CALVERT CLIFFS UNIT 2 CYCLE 8

TECHNICAL SPECIFICATIONS

CALVERT CLIFFS UNIT 2 CYCLE 8  
TECHNICAL SPECIFICATION CHANGES

Figure 2.2-1  
Peripheral Axial Shape Index,  $Y_1$  vs Fraction of Rated Thermal Power

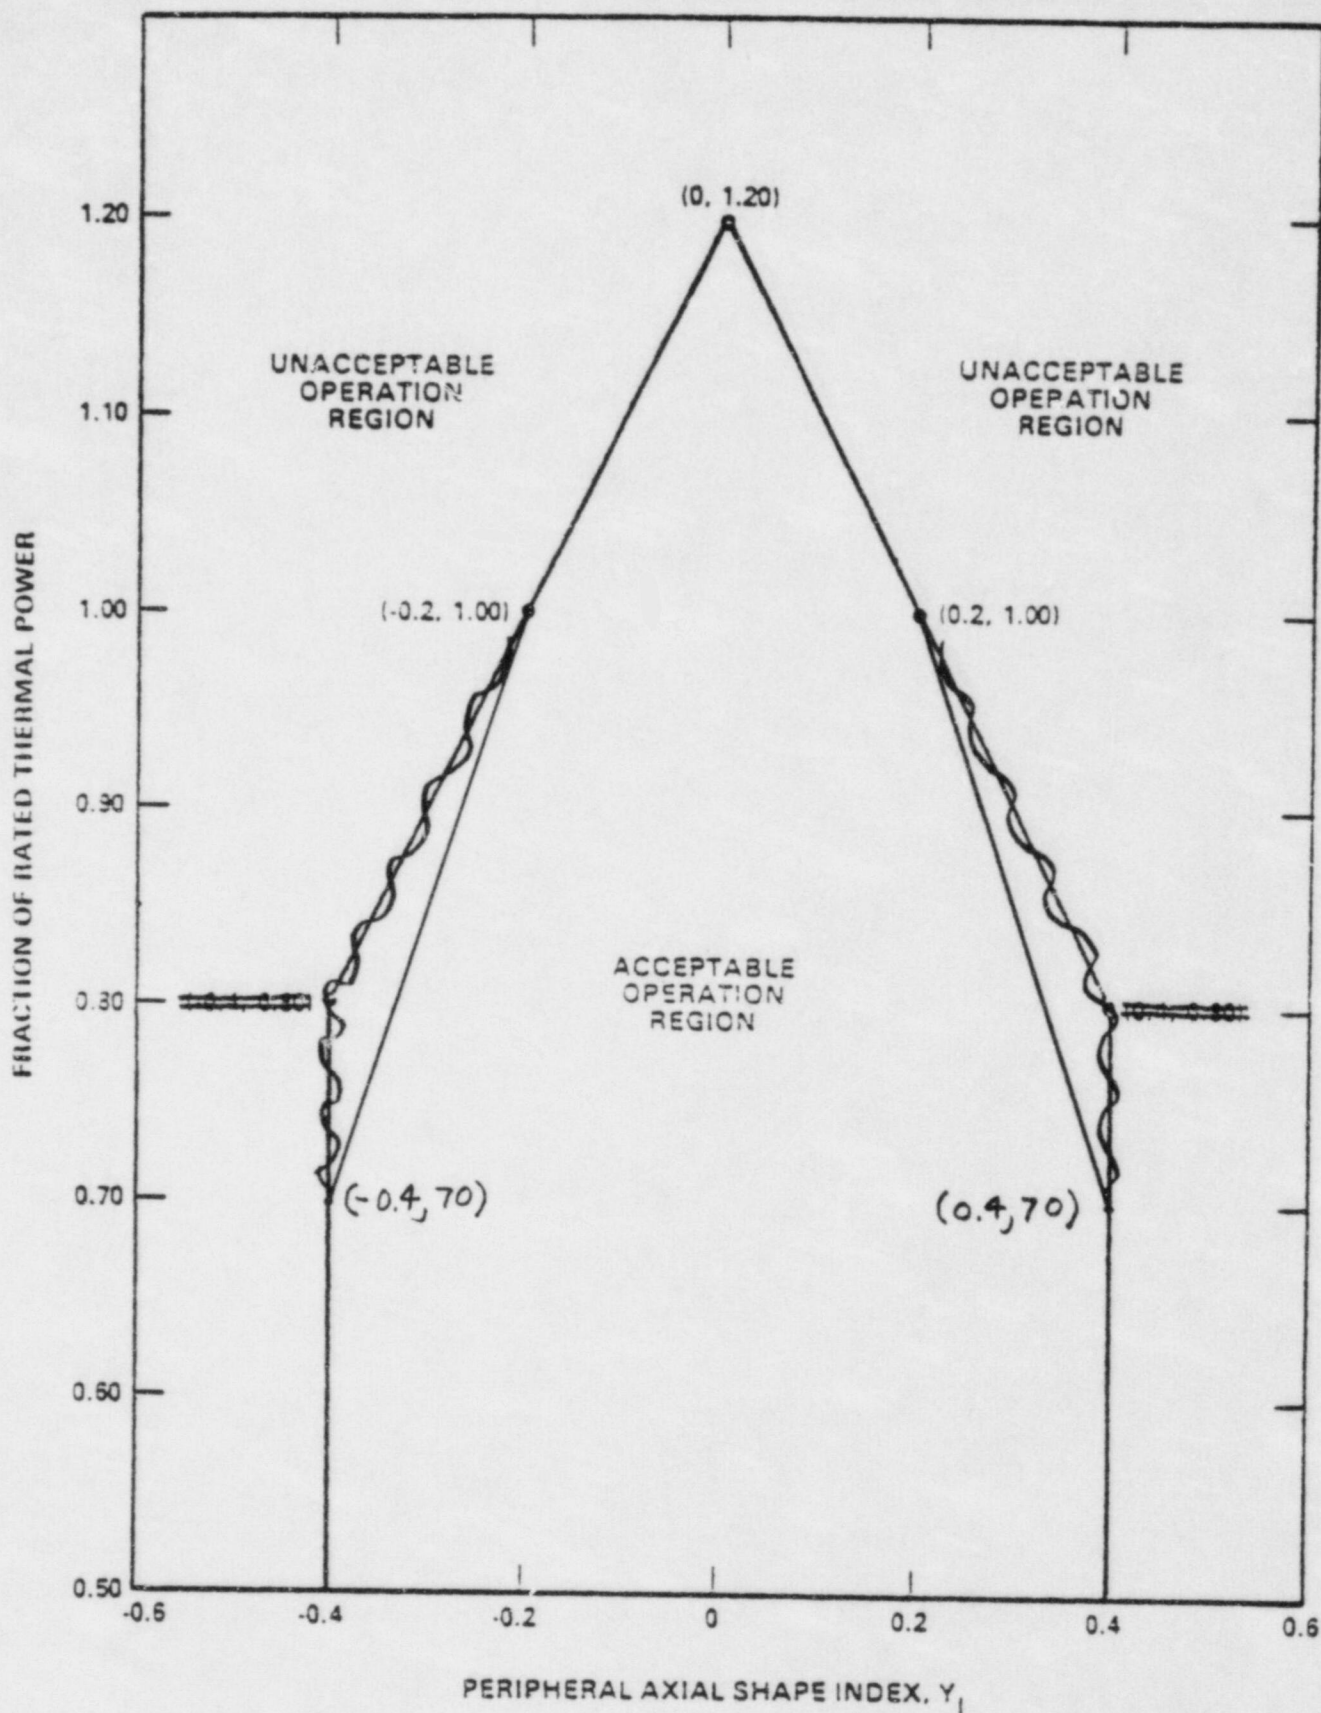
Tech. Spec. No. and Page	Action	Explanation	Support/Use
Figure 2.2-1 page 2-11	Modify Figure 2.2-1 as indicated to reduce the Acceptable Operation Region (AOR) between 70 and 100% power.	The AOR is being reduced to accommodate the implementation of 24-month, low-leakage cycles.	The setpoint analysis takes credit for this modification in demonstrating acceptable results for Unit 2 Cycle 8.
3/4.1.1.1 page 3/4 1-1	Change shutdown margin, $T_{avg} > 200^{\circ}\text{F}$ , from $3.5\%\Delta k/k$ to $4.5\%\Delta k/k$	The shutdown margin is being increased to support a revised Steam Line Rupture analysis. This increase is possible due to the additional scram worth available for low-leakage cores.	<ol style="list-style-type: none"> <li>1) The increase in shutdown margin is supported by the zero power scram worth demonstrated to be available in Table 5-2.</li> <li>2) The results of the revised Steam Line Rupture analysis were less limiting than those previously reported due to the increased scram worth available for low leakage cores. Consequently, this analysis was not reported (see Section 7).</li> </ol>

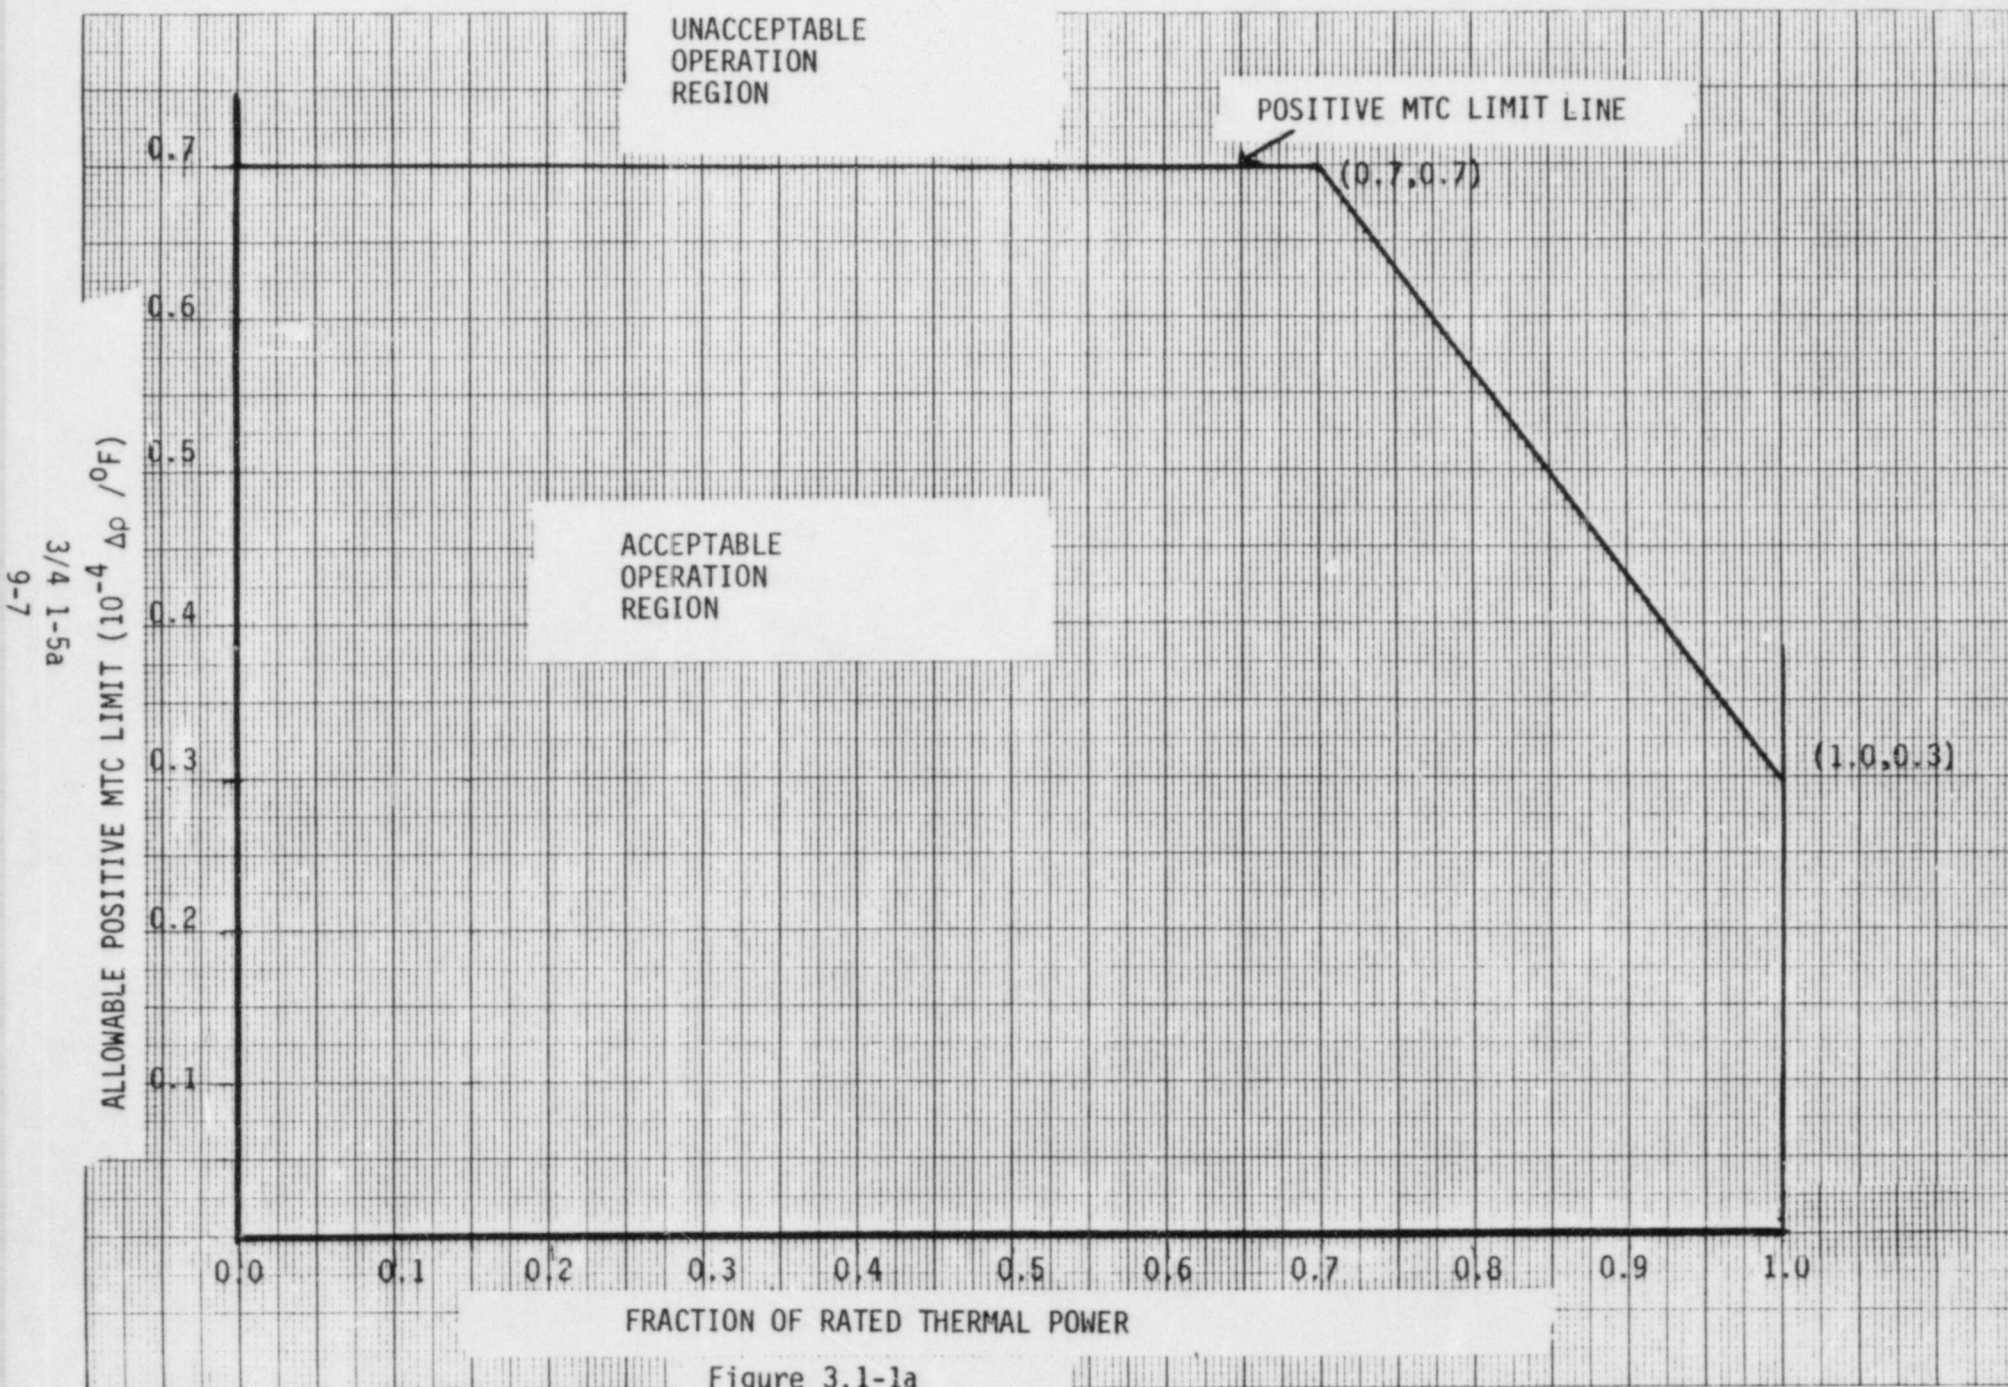
Tech. Spec. No. and Page	Action	Explanation	Support/Use
3.1.1.4 page 3/4 1-5	1) Condense Subsections "a" and "b" to a new Subsection "a" which simply refers to Figure 3.1-1a (new).  2) Change Subsection "a" to Subsection "b" without modifying the contents of this subsection.	The positive MTC limit above 70% power is being raised from $+2 \times 10^{-4} \Delta \rho / ^\circ \text{F}$ to a value which varies linearly from $+3 \times 10^{-4} \Delta \rho / ^\circ \text{F}$ at 100% power to $+7 \times 10^{-4} \Delta \rho / ^\circ \text{F}$ at 70% power. This change is being made to accommodate the implementation of 24-month cycles, to eliminate startup delays and to facilitate a rapid power ascension program (see Section 10.0).	1) The results of a revised Feedline Break (FLB) analysis which accounts for this change in MTC limit were less limiting than those previously reported. Since the results are less limiting than those previously reported, this revised FLB analysis is not contained herein.  2) The rapid power ascension program described in Section 10.0 takes credit for this change in MTC limit.

3.1.1.4 page 3/4 1-5a (new)	Insert enclosed new Figure 3.1-1a after Page 3/4 1-5.	See change for page 3/4 1-5.	See change for Page 3/4 1-5
B 3/4.1.1.1 and B 3/4.1.1.2 page B 3/4 1-1	Change EOC shutdown margin, $T_{avg} > 200^\circ \text{F}$ , from $3.5\% \Delta k/k$ to $4.5\% \Delta k/k$	See change for Tech. Spec. 3/4.1.1.1	See change for Tech. Spec. 3/4.1.1.1.

→ a. Less positive than the limit line of Figure 3.1-1a, and
